工程指示 / 要求簡箋(E.I.)

工程指示編號：EI / 6877 / 23

工程名稱：將軍澳日出康城 11

工程項目：後加 AC-Grille (凳仔碼) (T1-T3) 42 隻 地盤用

AC-250

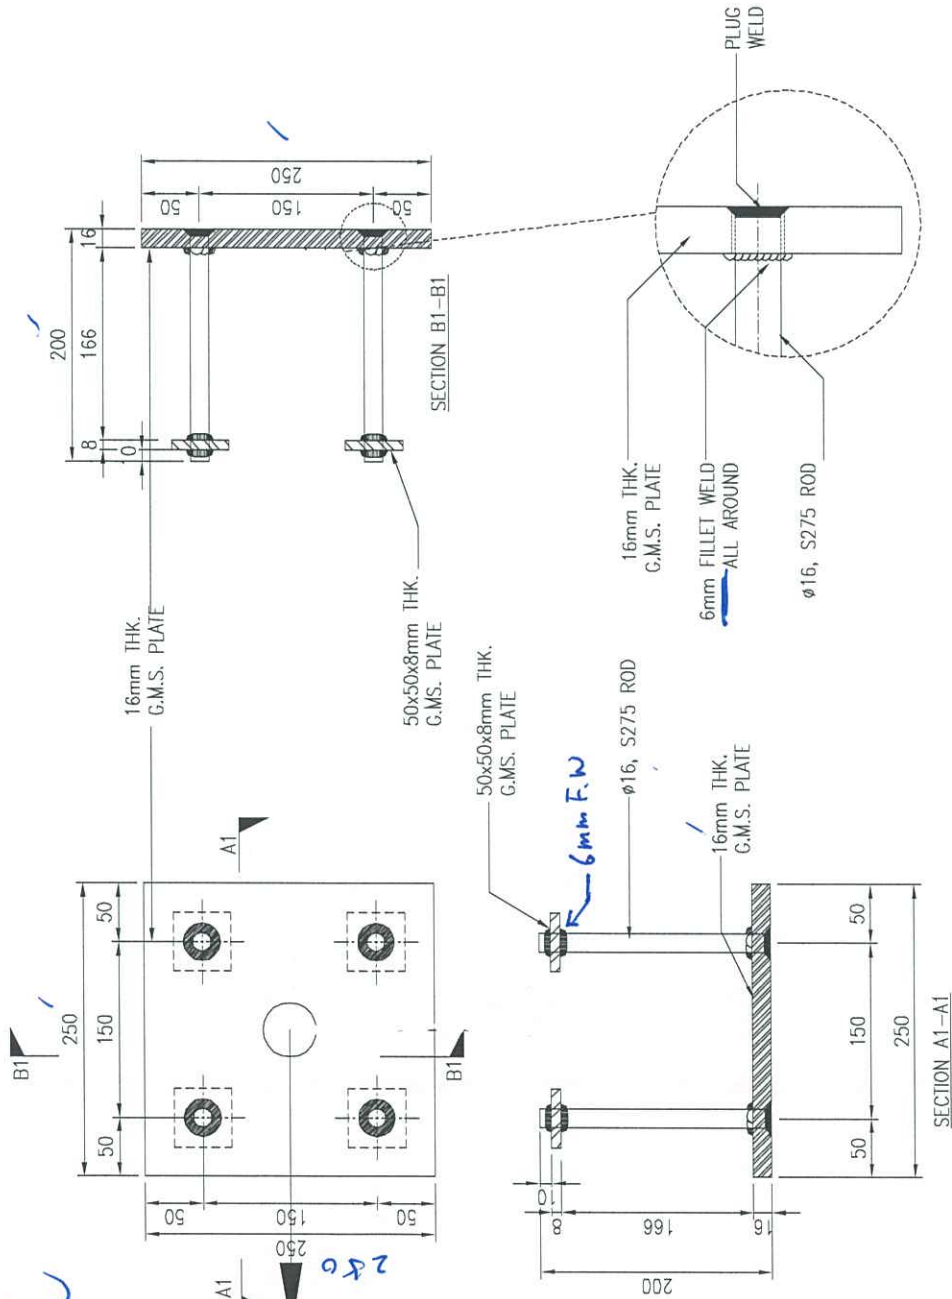
請按 BM 及加工圖訂購預留碼送地盤安裝用 (凳仔碼)

1. 附上分層表，分座打扎。

2. 凳仔碼需驗焊， Fillet weld, 100% Visual, 10% MPI (For AC Grille)

3. 請提供 Mill cert

4. 疏氣孔為 Ø20mm
